**STATE OF HAWAII
DEPARTMENT OF TRANSPORTATION
AIRPORTS**

**ADDENDUM NO. 3
FOR
MKK TERMINAL BUILDING ROOF REPLACEMENT
MOLOKAI AIRPORT
HOOLEHUA, MOLOKAI, HAWAII
STATE PROJECT NO. CM2521-33**

June 10, 2026

DATE:	DWG. NO.
DEC 19, 2025	A401
SHEET:	
13 OF 30 SHTS	6/4/26

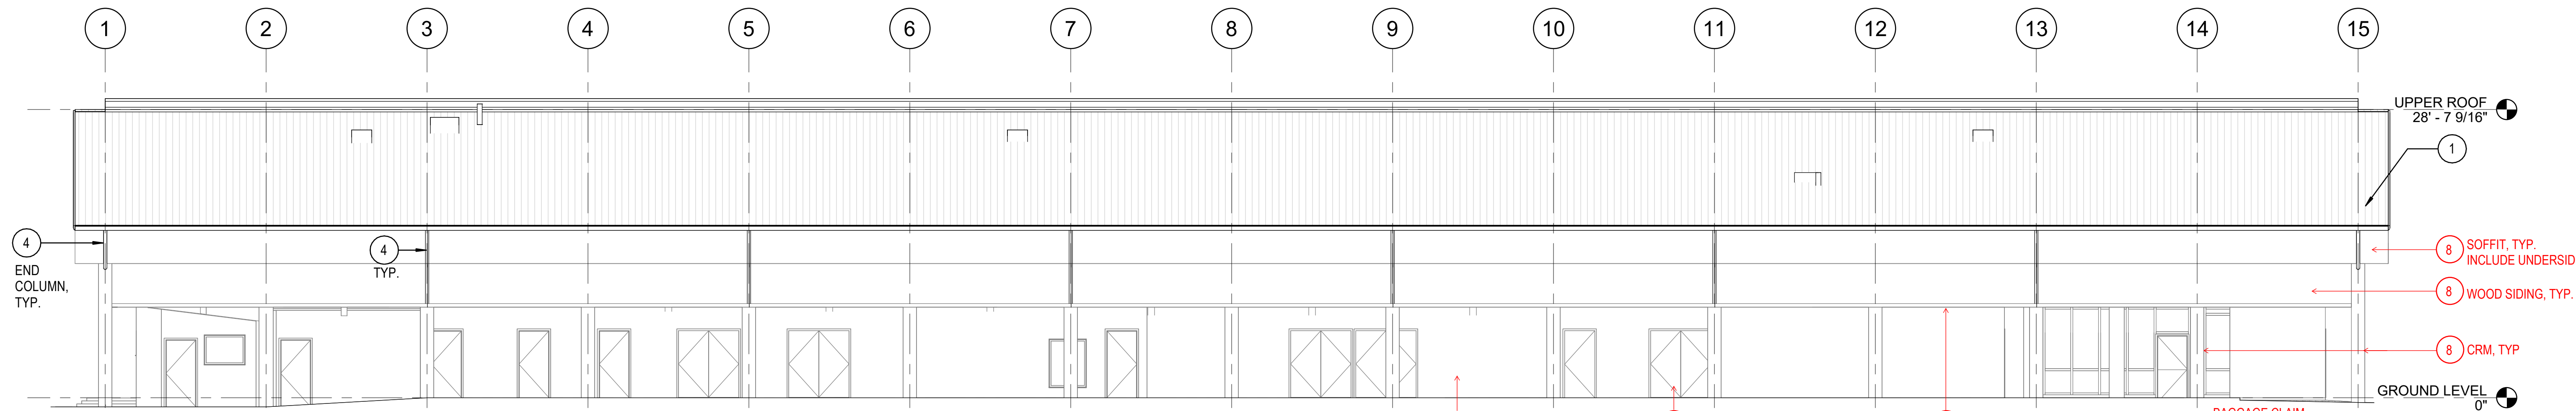
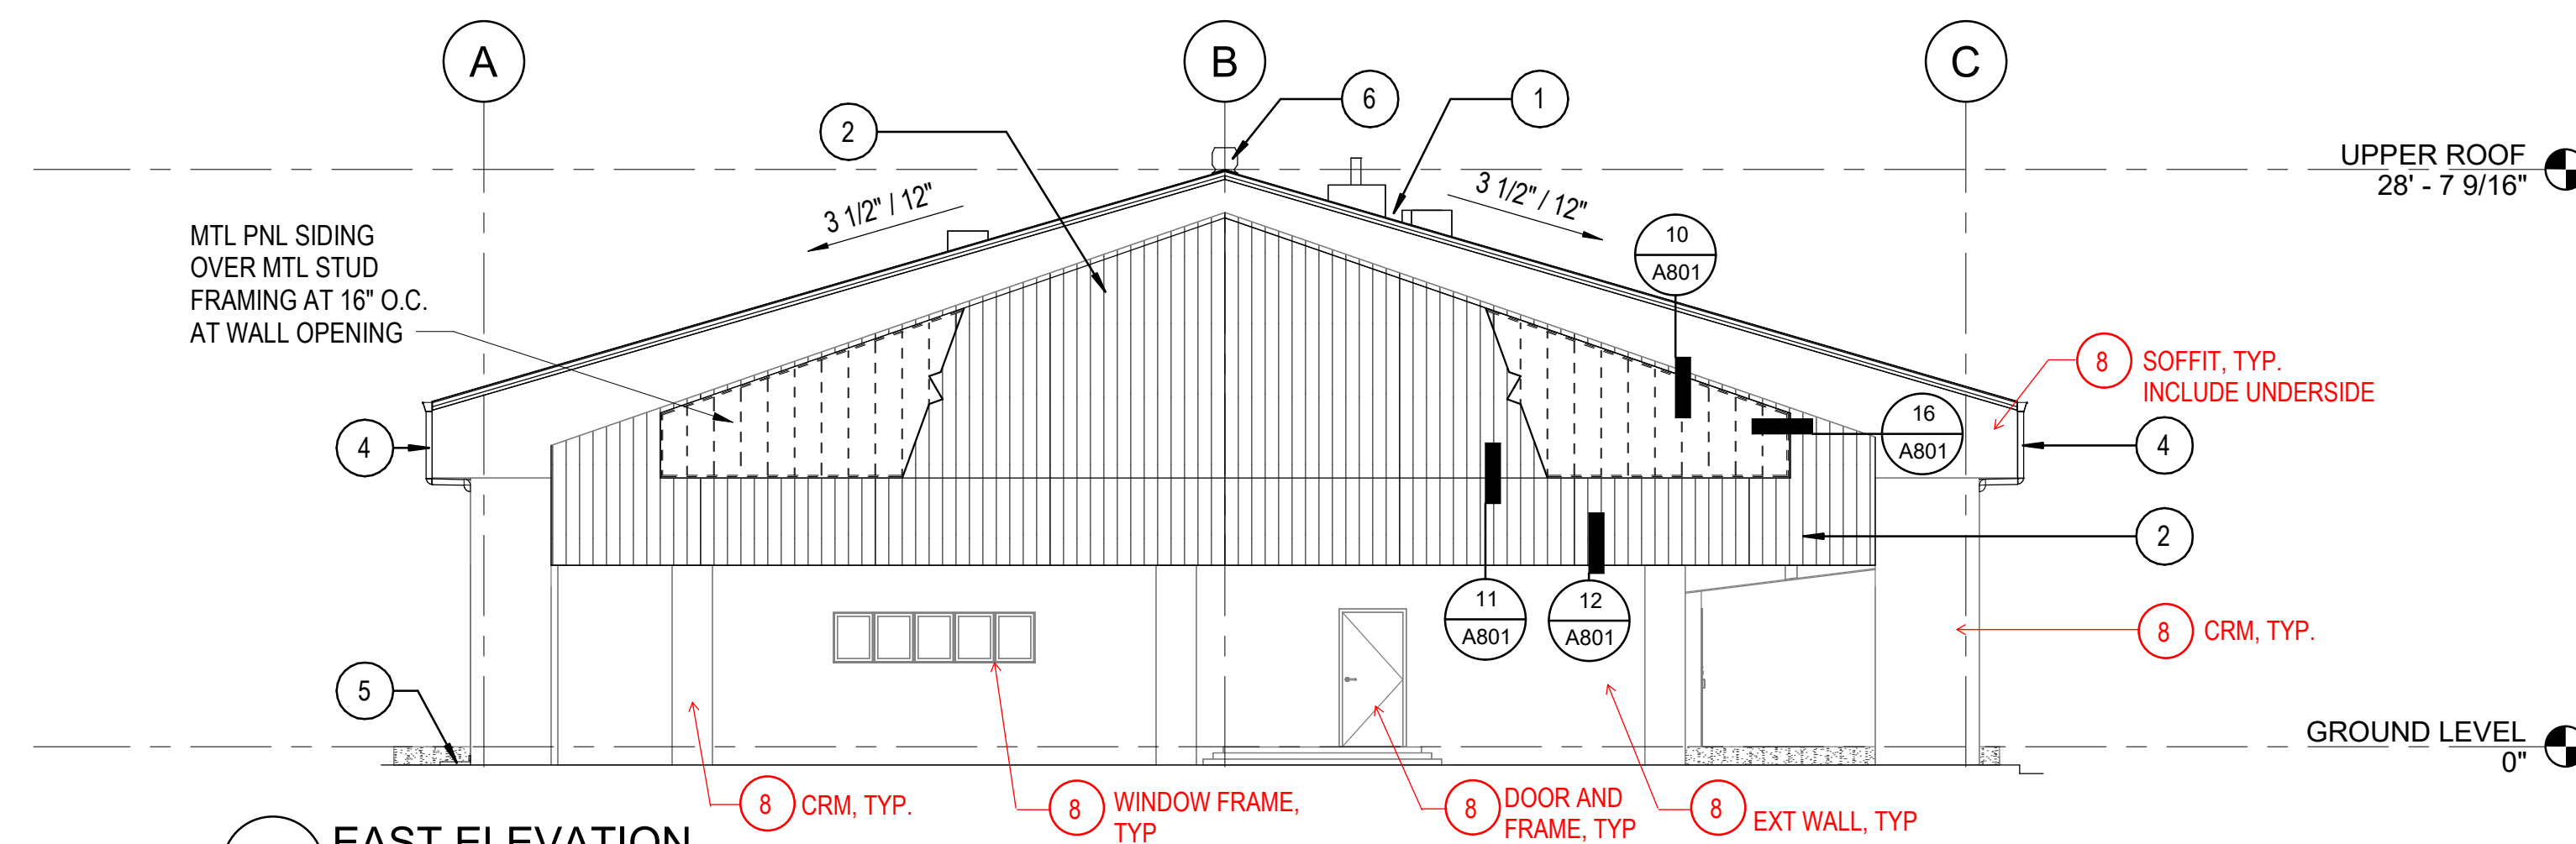
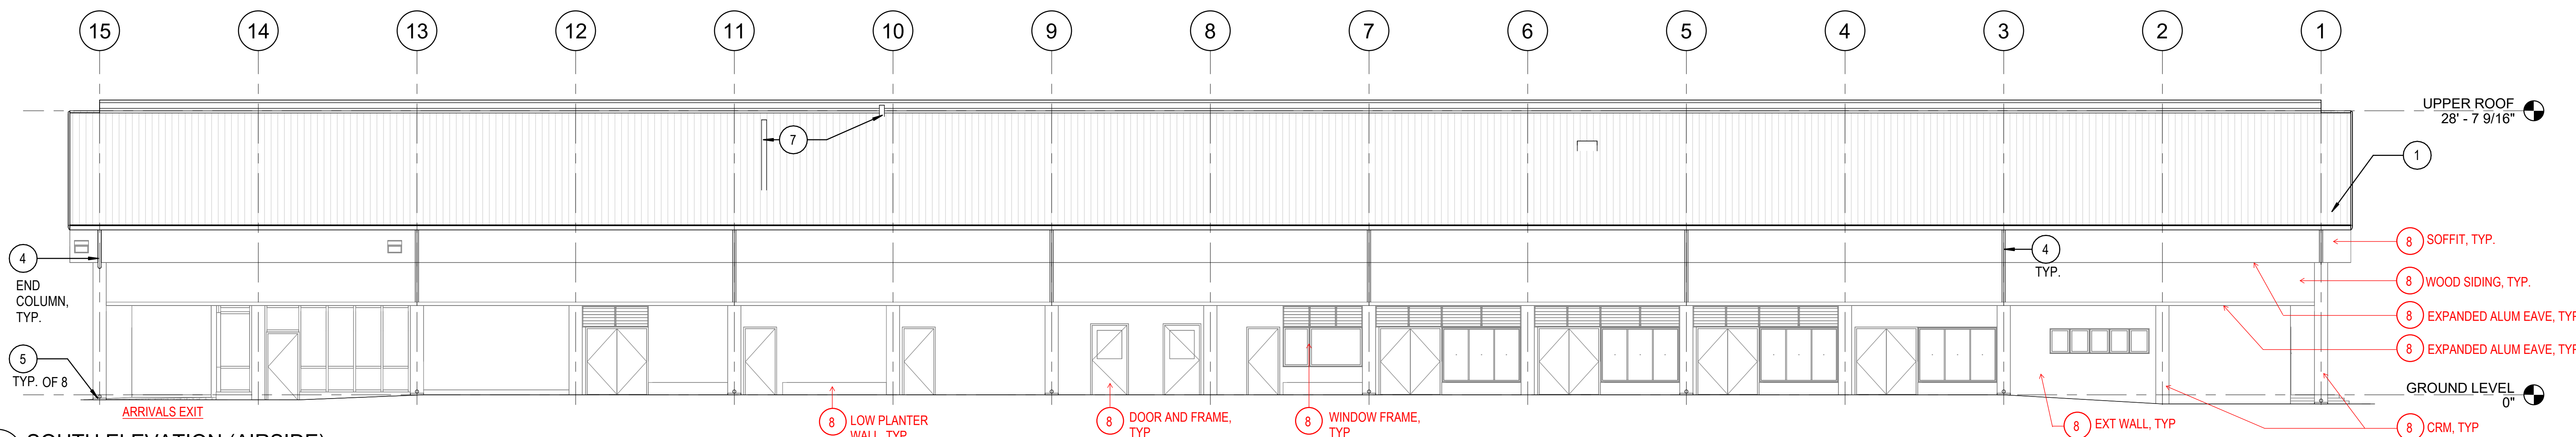
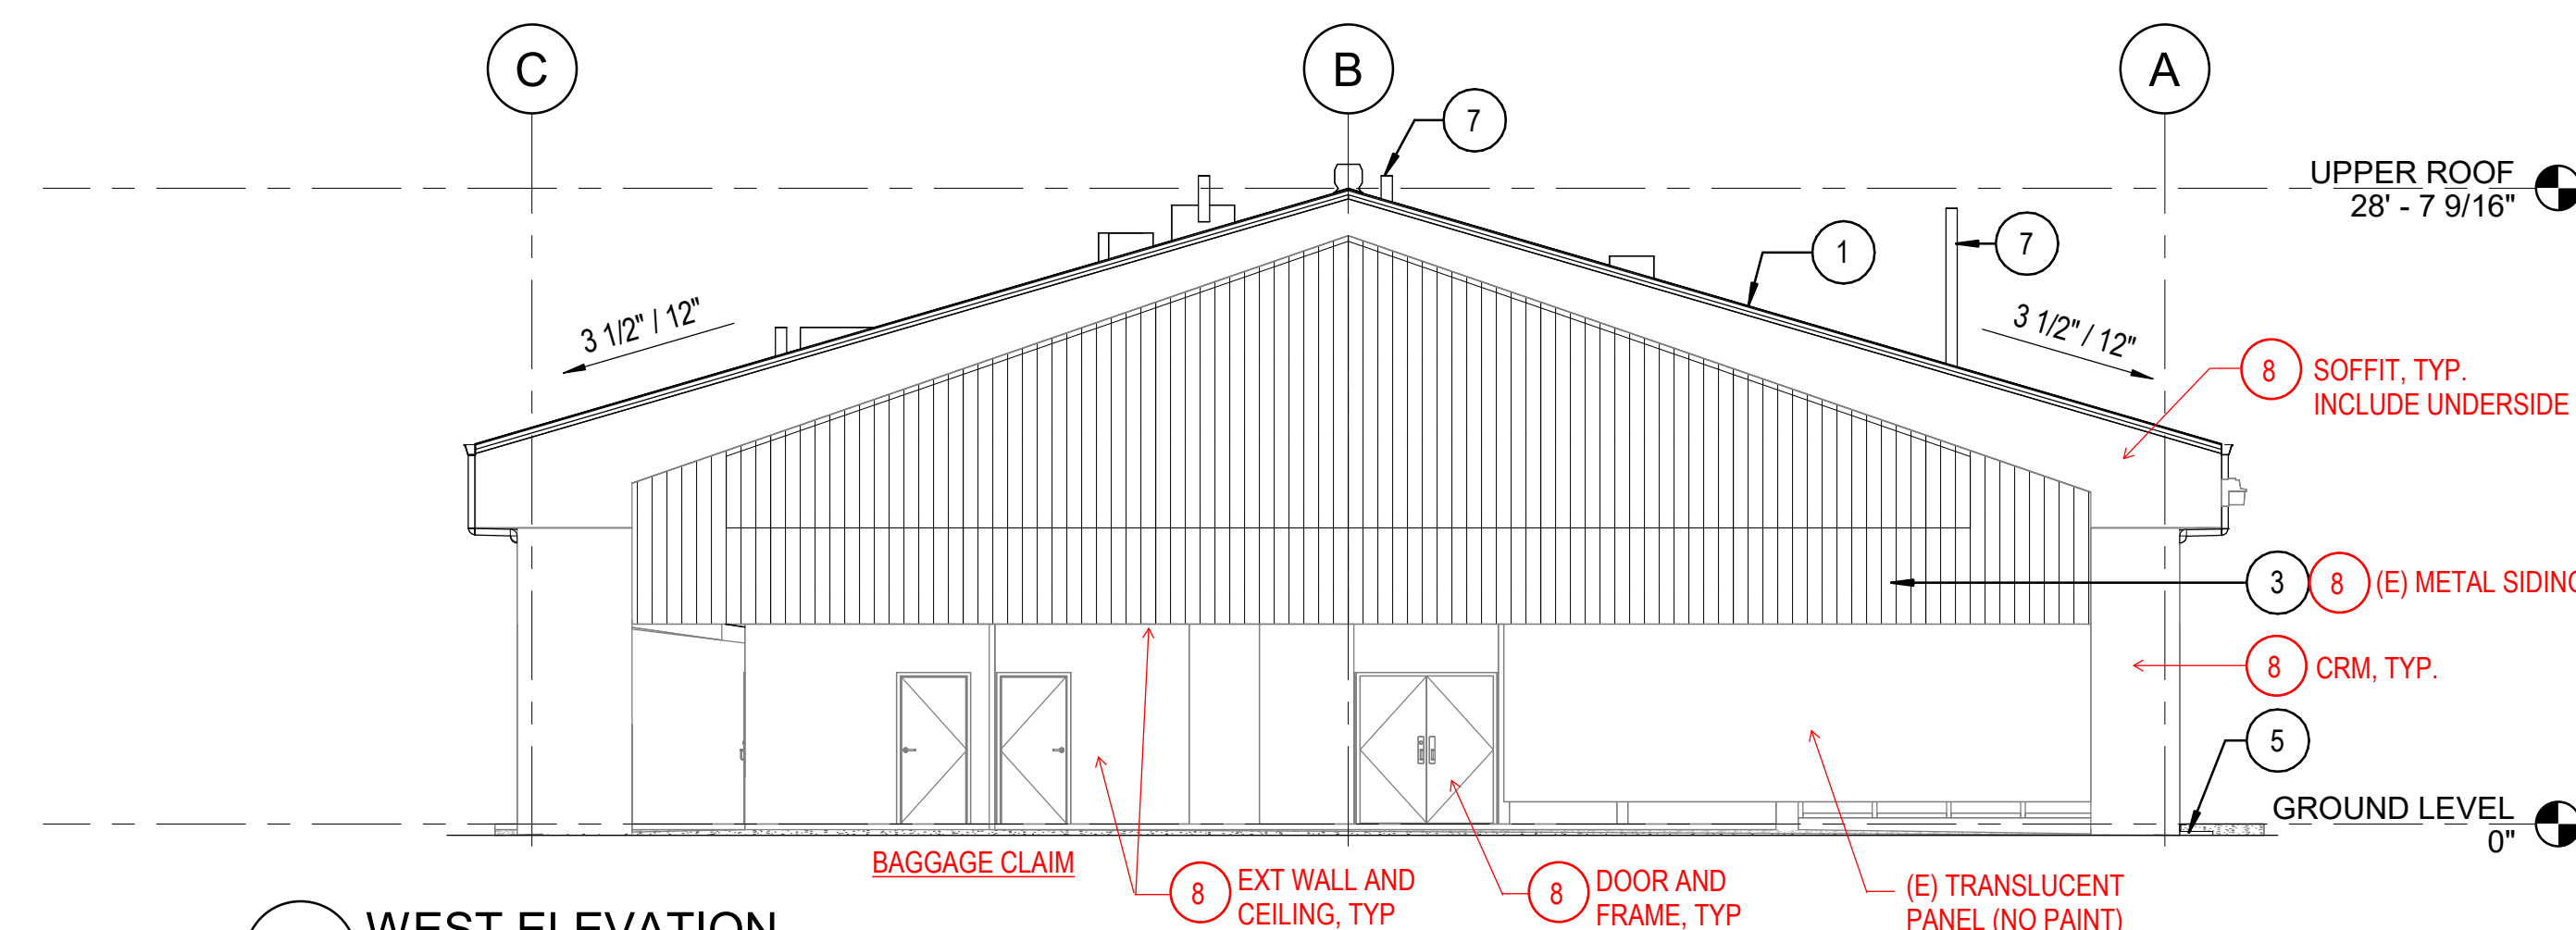
8. **Detail #2, Page A-401 calls for "metal panel siding over stud framing at 16" o.c at wall opening". There is no specification on details for stud connections to existing structure. Please provide details, gauge, size of framing material etc.**
